**ISSUE:** Certificate of Appropriateness for alterations

**APPLICANT:** Bob & Becky Cady

**LOCATION:** Old and Historic Alexandria District  
330 South Lee Street

2 REAR ELEVATION (EAST) - EXIST & DEMO

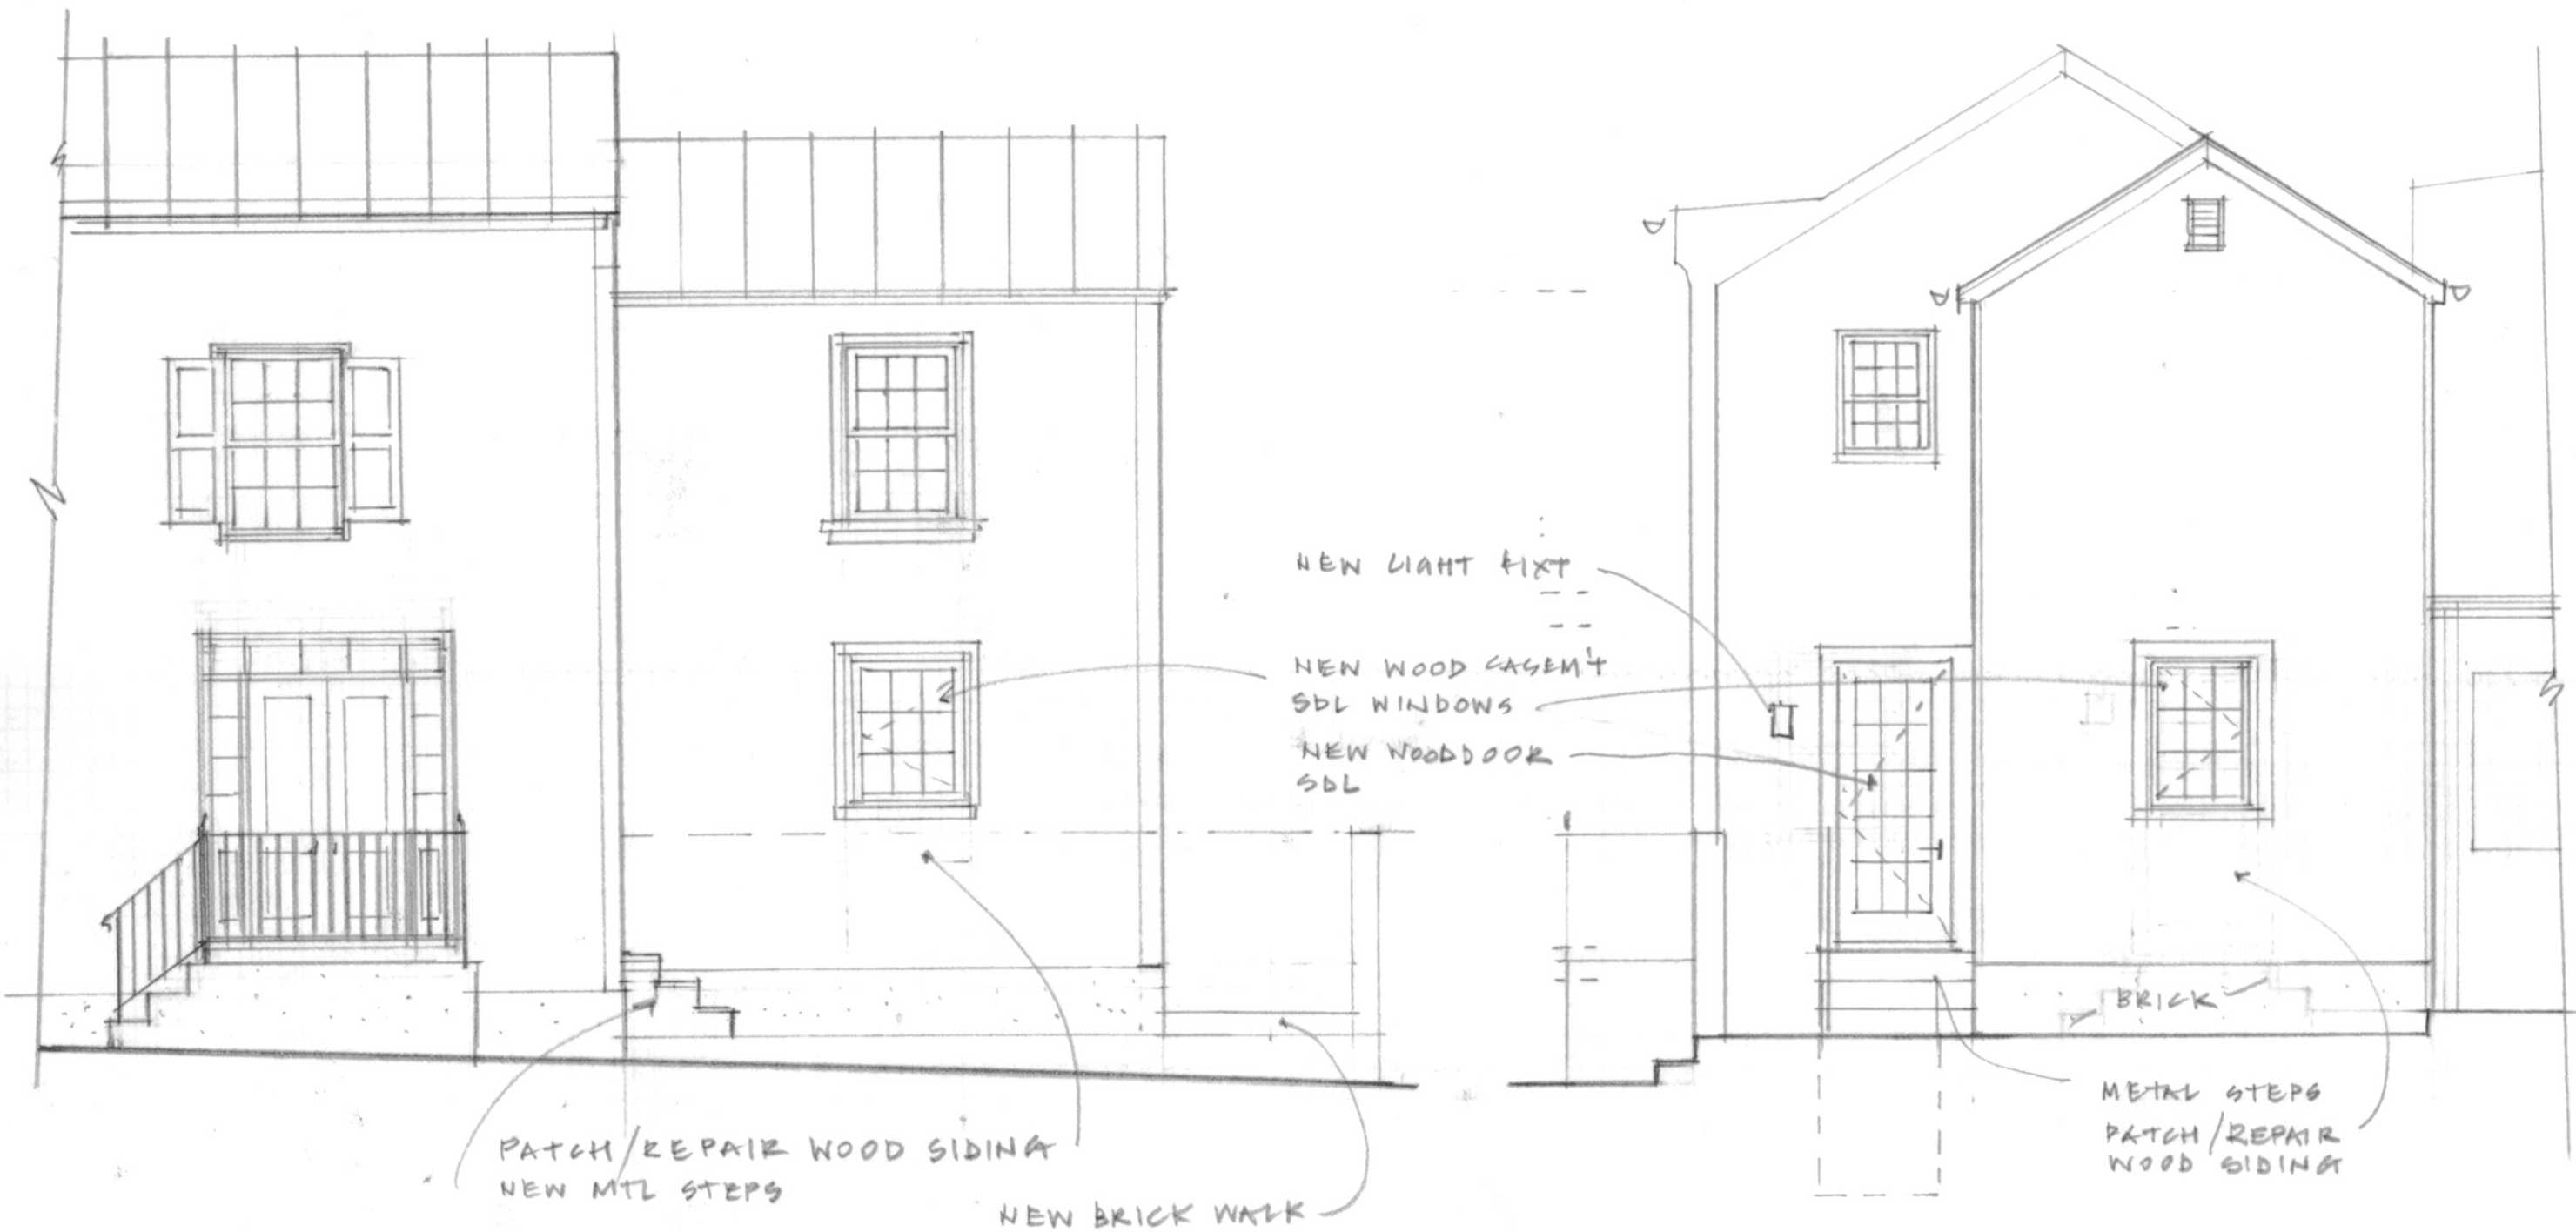
Staff has no objection to removal of the existing six-over-six double-hung wood window and partial demolition of approximately thirteen square feet of the wall of the east elevation of the main block of the house to install a new wood SDL door because the existing window is a 20<sup>th</sup> century replacement. Staff notes that the total wall area to be demolished for this alteration is less than twenty-five square feet, so a separate Permit to Demolish is not required. A very similar alteration was approved by the BAR last year for the townhouse at 201 North Columbus Street on the Cameron Street side facing Christ Church. Even though the subject property sits on a corner lot, only the upper portion of the proposed door will be visible from the street, as there is a six-foot tall brick garden wall enclosing the small side yard which obstructs the visibility of the east elevation first floor where the door will be installed (Figure 2). Changes back and forth between doors and windows is not an unusual request on the rear of a house and is frequently approved by the BAR, so long as a minimum of historic fabric is being removed.

The applicant is also proposing removal of an existing solid door at the ell's east elevation at the rear to install a wood SDL casement window with nine lights. The *Design Guidelines* state that:

Staff supports the casement window at the east elevation of the ell because it complies with the *Guidelines* recommendations by being minimally visible from a public way and placed at the rear of the building. Casement windows were occasionally used on dormers, basement windows and the service portions of historic structures, as they were less expensive than double hung windows and provided more ventilation for the same size window.

The existing six-over-six sash window on the ell's south elevation at the first floor is a 20<sup>th</sup> century replacement that presently matches the six-over-six fenestration pattern and double hung operational type on the remainder of the house. Even though the ell's south elevation faces Wolfe Street and the existing six-over-six double-hung window is partially visible from the public way (Figure 3), staff has no objection to its replacement with a wood casement window with nine lights, as this is the number of lights currently visible from the public right-of-way on the existing window, so the visual difference for the public will be minimal. While this facade of the house is street facing and is not technically a rear elevation, this window is located on the service ell of the property and the Board routinely approves fenestration modifications to accommodate a more functional interior layout. In addition, the design will be improved if windows on the south and east elevations of the first floor of the ell match.

Staff recommends approval of the Certificate of Appropriateness with the condition that:

1. All new windows and doors must comply with the *Alexandria New and Replacement Window Performance Specifications*.
